Subject: TS30 Mux Units Pin Changing and Diode Checking Bulletin

Bulletin Type: Service Campaign Recall

Bulletin No: TS30-SR-2501

Vehicle Model: TS30

Figure 1.1 Existing Diagram

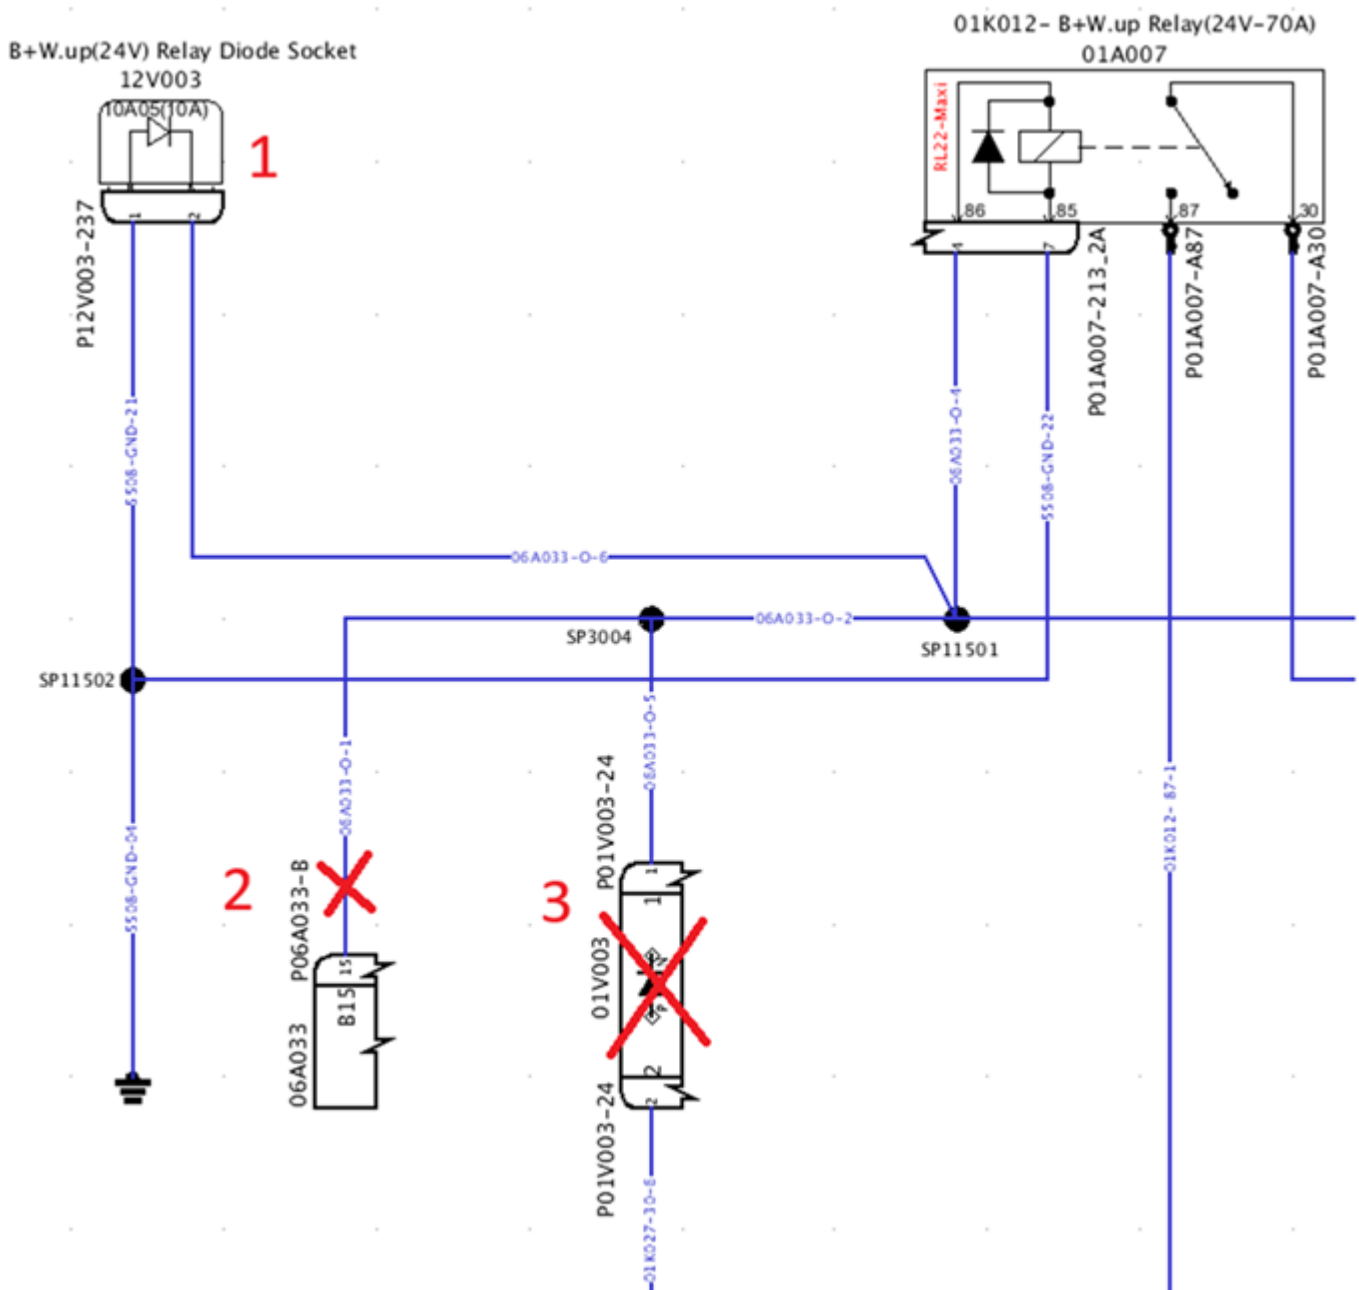
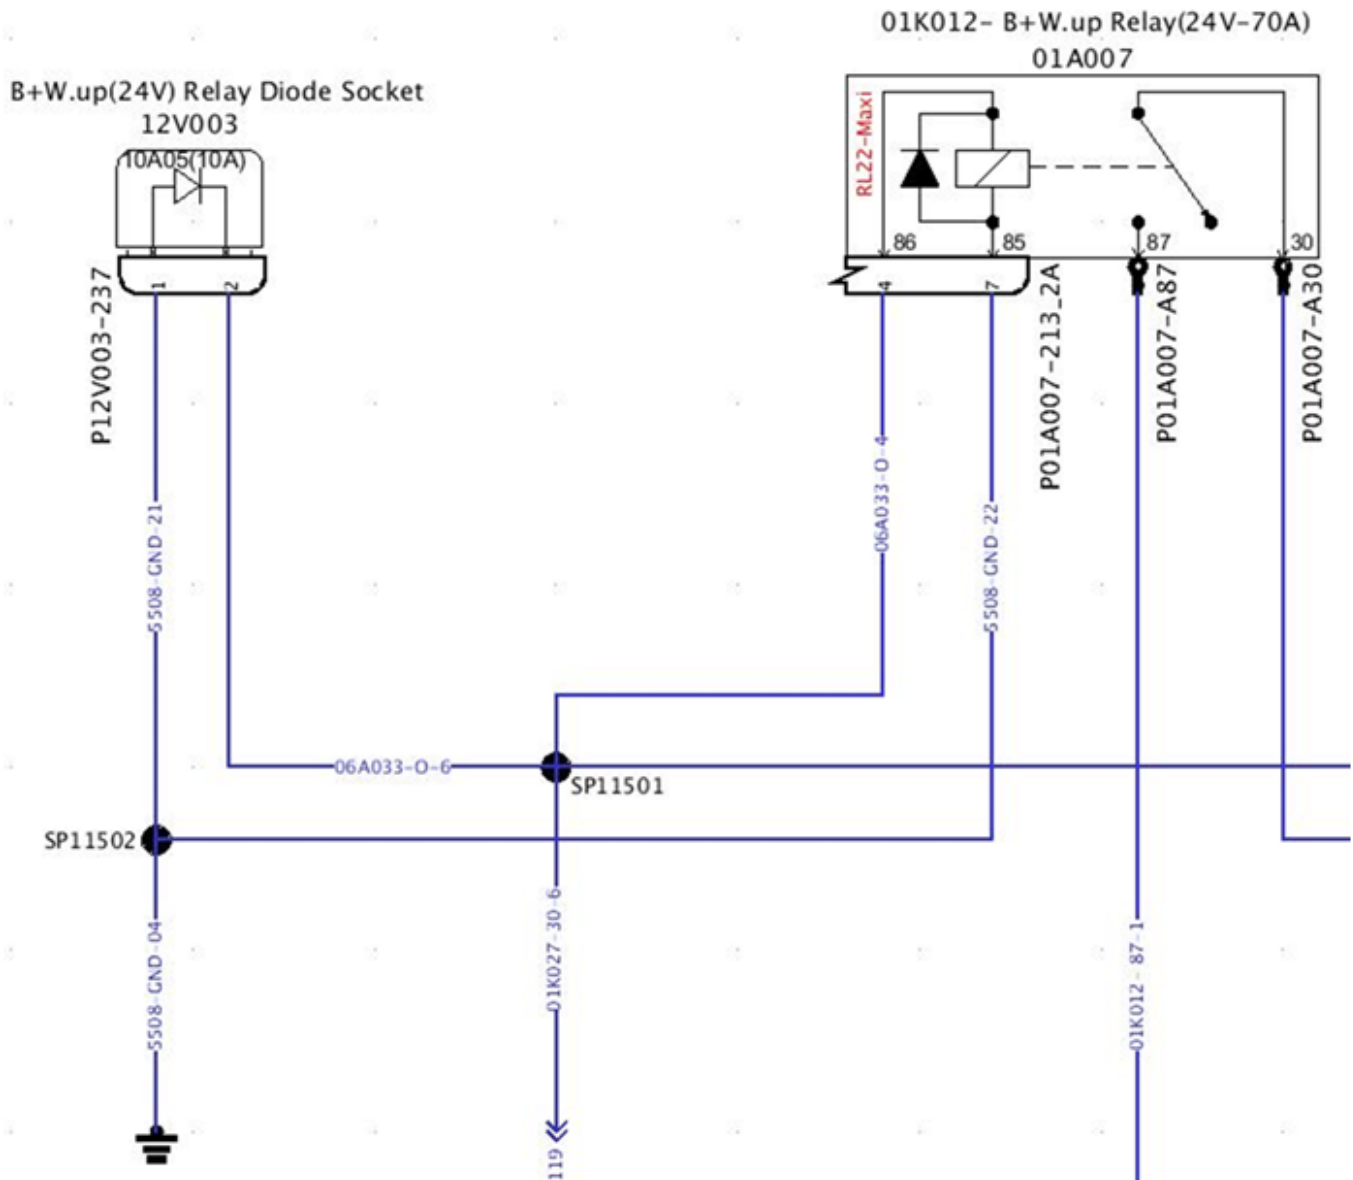
2.) Step 1: Check the diode on the “P12V003-237” socket. If there is no diode on this pin, you should add the diode that in the part list , as “Figure 1.1”.

Step 2: Remove the cable on pin B15 in the P06A033-B socket on the front relay panel. Blind and insulate the removed cable with electrical tape “Figure 1.1”

Step 3: Remove “P01V003-24” diode. Then join the cables “01K027-30-6” and “0A6033-0-5” each other. Use solder for joining wires. Then make sure that there is a good joint and insulate joint with electrical tape.

The implementation must match the Figure 1.2.

Figure -2- Moving B16 pin to B24

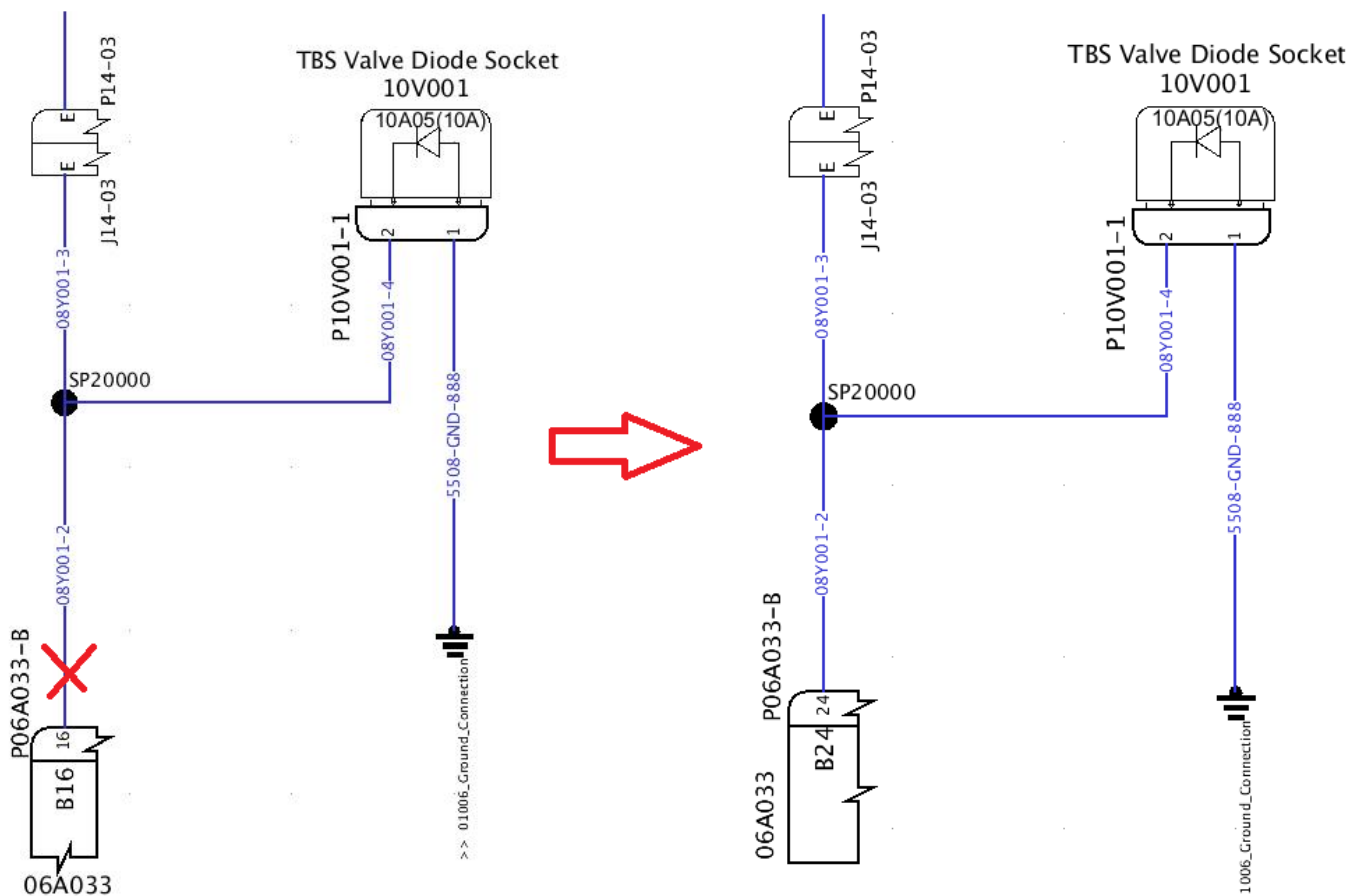
3.) Remove the cable “08Y001-2” cable from front relay panel P06A033-B pin **B16**, cut the its terminal from wire then crimp the new terminal “9402-158Y”. Connect this cable to P06A033-B pin “**B24**” in Figure 2.

Then check the diode on the “10V001” socket. If there is no diode on this pin, you should add the diode that in the part list , as “**Figure 2**”.

Figure 3.2-Implemented Diagram for Figure 3.1

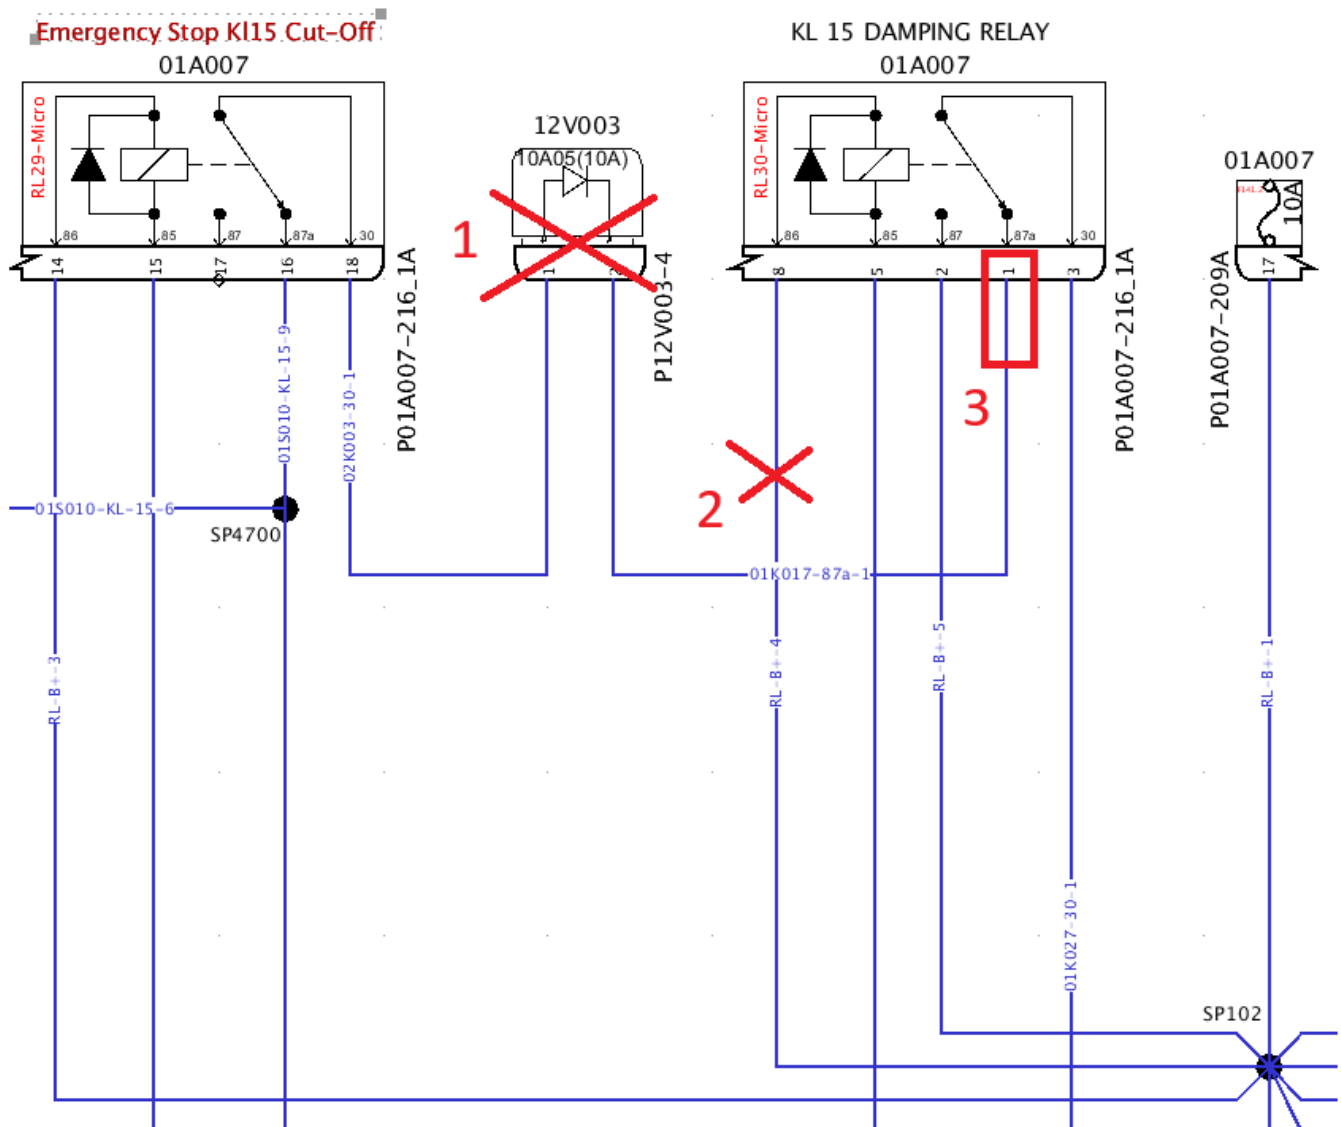
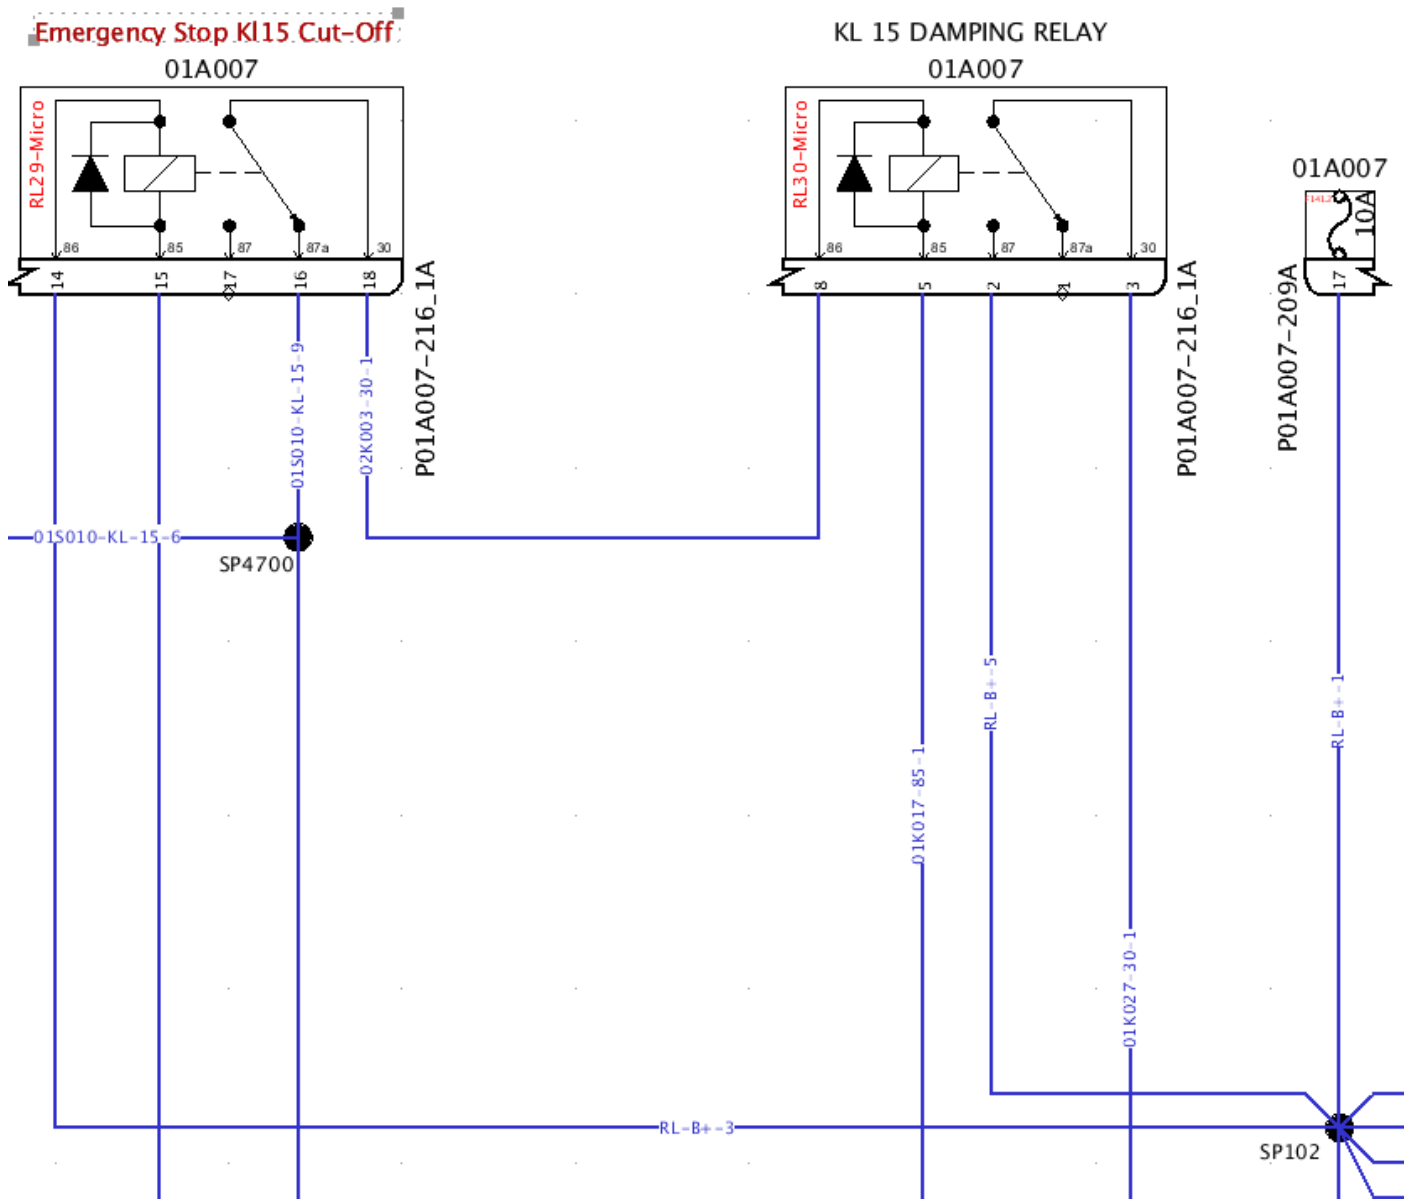
3-) Step 1: At front relay panel, remove the **P12V003-4** diode and join the “**02K003-30-1**” cable and

“**01K017-87a-1**” cables each other. Use solder for joining wires. Then make sure that there is a good joint and insulate joint with electrical tape.

Step 2: Find “**P01A007-216-1A**” socket from the front relay panel, remove the “**RL-B+-4**” cable from pin8 . Then blind and insulate the removed cable with electrical tape.

Step 3: Remove “**01K017-87a-1**” cable from pin1 of “**P01A007-216-1A**” socket then connect it to pin8.

The implementation must match “Figure 3.2”

Figure-4-

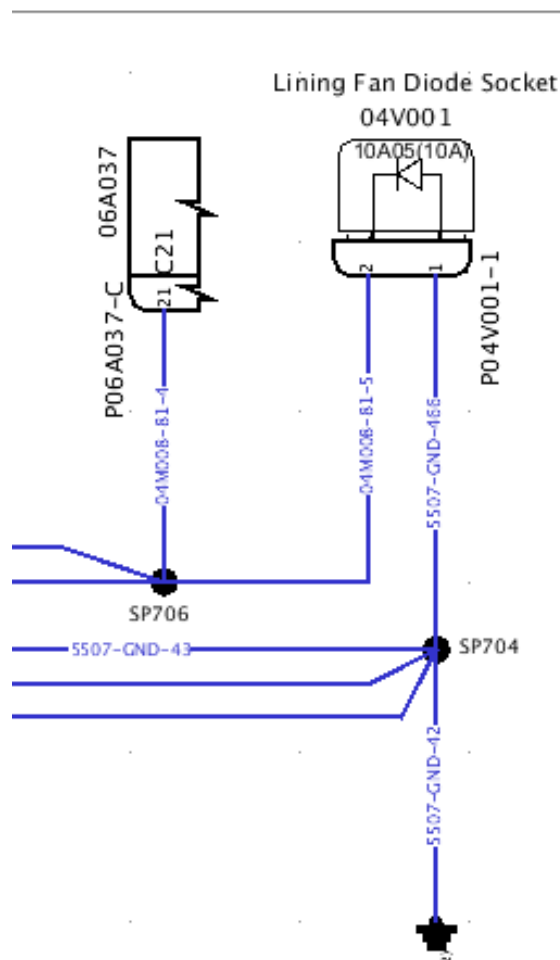
4-) Open the rear relay panel lid. Locate the MUX5-B 2.1 Which is numbered as 06A037.

If there is a diode, then check the diode polarity and make sure that this is good and working properly. If this diode is damaged, replace it.

Figure 5

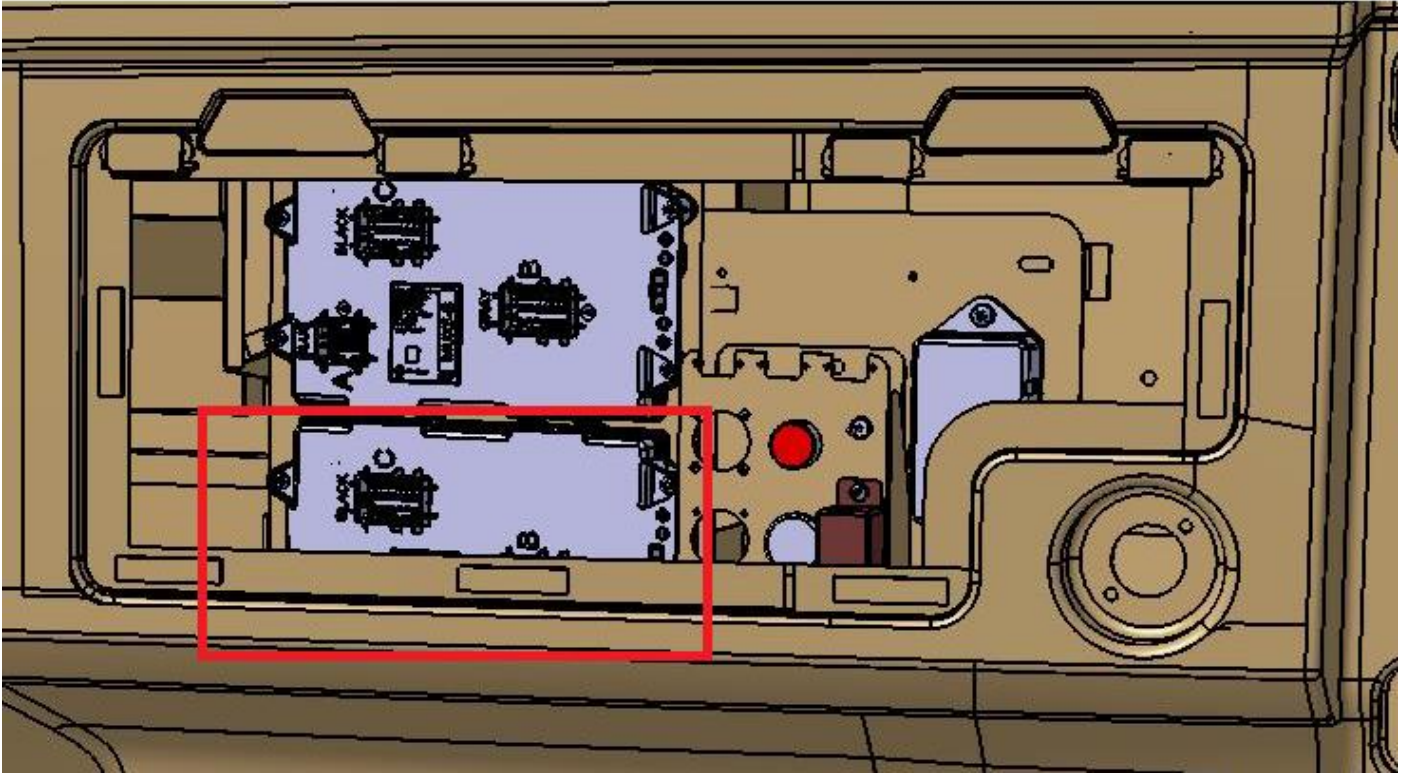
6-) Open the front body panel and locate Mux 1.3 06A035.
